JOINT REGIONAL PLANNING PANEL (East Region)

JRPP No	2016SYE007
DA Number	DA 15/191
Local Government Area	City of Botany Bay Council
Proposed Development	<p>Stage 1 Masterplan Development Application for the consolidation of 16 Lots (Lots 11-26 DP 29697) to create the subject site with a combined area of 12,602sqm to accommodate:</p> <ul style="list-style-type: none"> • Four x eight (8) storey commercial towers with a total GFA of 37,805sqm; • 3 levels (two levels above ground and one level partially below ground) of car parking for 490 vehicles, 43 bicycles and 4 loading bays under a landscaped podium; • Extensive landscaping of 8,605sqm including ground level setbacks, green façade, podium level landscaped area and green roof; • A pedestrian overpass linking the podium level on either side of the cul-de-sac at the end of Chalmers Crescent; and
Street Address	7-9, 14-18 and 19-21 Chalmers Crescent, Mascot
Applicant/Owner	F Mayer (Imports) Pty Ltd C/- Neustein Urban

Assessment Report and Recommendation Cover Sheet

Figure 7. Proposed Site Plan

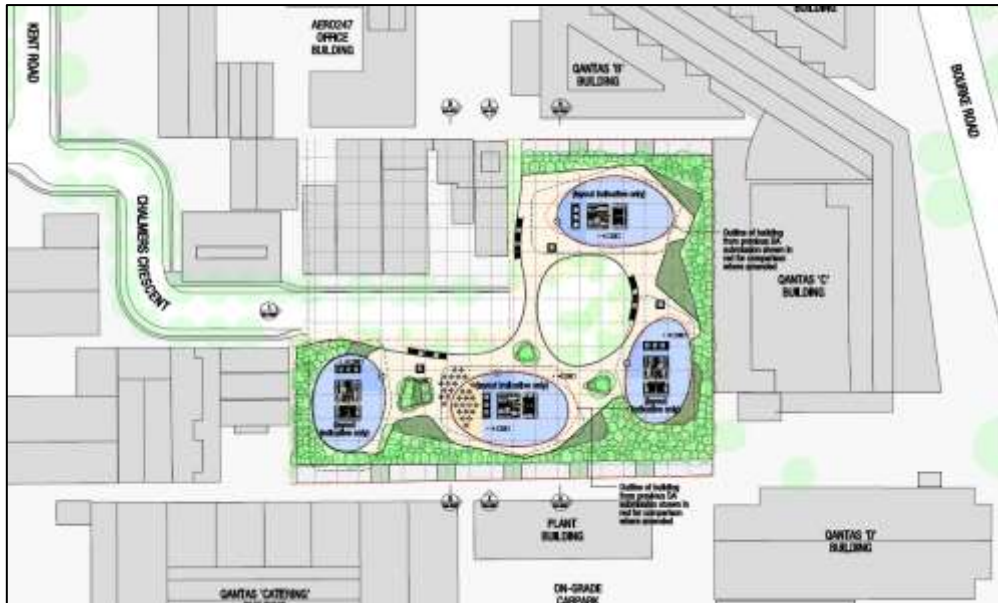
Due to the current design being built on top of the road, the overpass pedestrian crossing has not received consent by Council for its construction. Therefore the plans should be modified to contain all development within their site boundaries, within appropriate setbacks.

Control C2 of Part 3A.3.1 and Control C10 of Part 3A.3.4 of the BBDCP 2013 requires that service vehicles enter and exit the premise in a forward direction. Swept path diagrams have been provided to demonstrate that the vehicles will reverse into the loading bays and exit in a forward direction. Council does not support this arrangement and require forward ingress and egress from the site. This site is large enough to provide this.

to enter and leave the site in a forward direction. This has not been demonstrated and is not supported. Amended plans should be provided to show that all servicing and access onto the site occurs within the site boundaries and in a forward direction.

Figure 10. Proposed Western Elevation

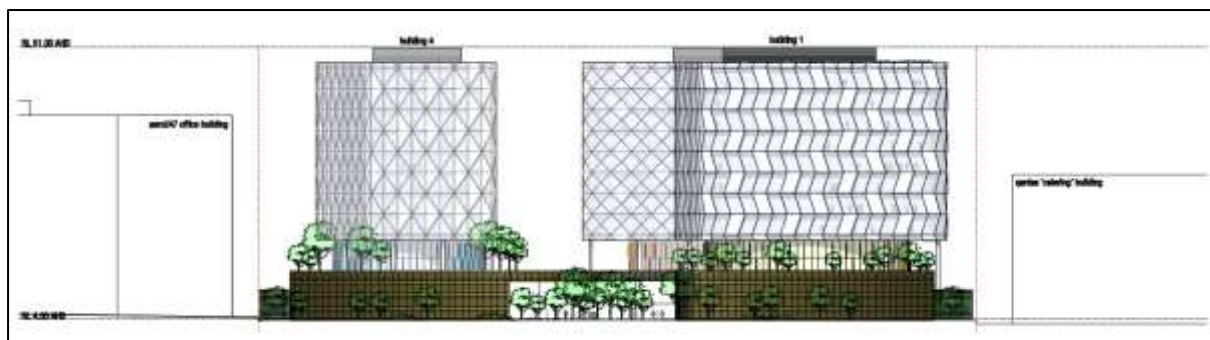
The height of building (HoB) of the proposed development is 46.4 metres and therefore exceeds the maximum building height of 44 metres permitted under Clause 4.3 of the BBLEP 2013. The non-compliance in height is attributed to the lift overruns and plant cores which surpass the building height by 2.4 metres. Accordingly, the proposal is seeking a variation to

The variation is 2.4m and is not acceptable as the height exceedance is attributed to the lift overrun/plant cores. Compliance with other numerical controls will allow for compliance in height and Council is of the opinion that there is no supportable justification in contravening the standard. Compliance with the standard is reasonable and necessary as it will dictate the height of the subject and future surrounding old industrial stock in the area. Any exceedance in the height is not what Council has envisaged for the locality in this particular zone.
